Re: The Aurora Highlands – Contextual Site Plan – Filings 1-3 (#1324907)/Pre-Application Meeting held October 11, 2018

PLANNING DEPARTMENT COMMENTS

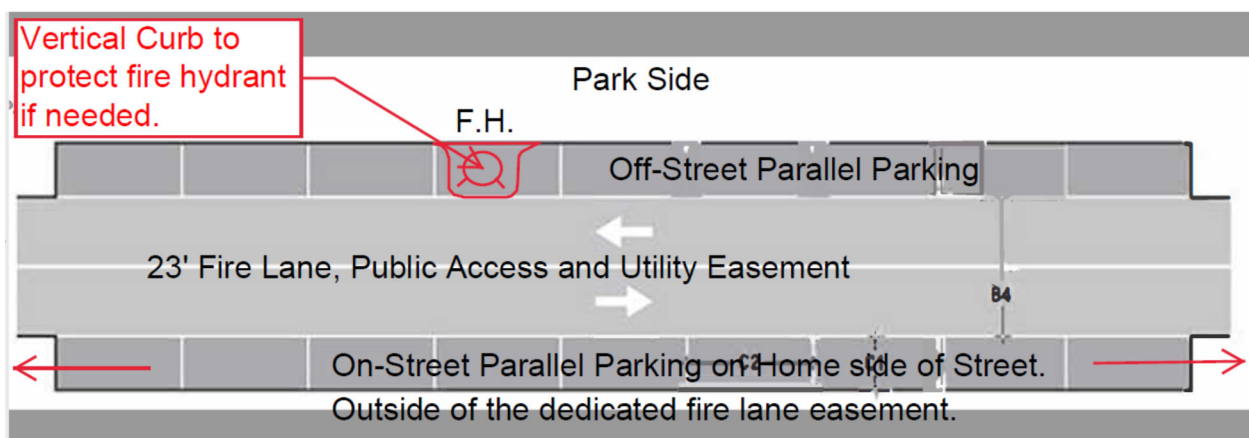
- The fire lane is typically located on the open space side allowing a 7-7 ½ foot parking area in front of each home. This parking area cannot encroach into the adjacent fire lane easement.

Response: Noted.
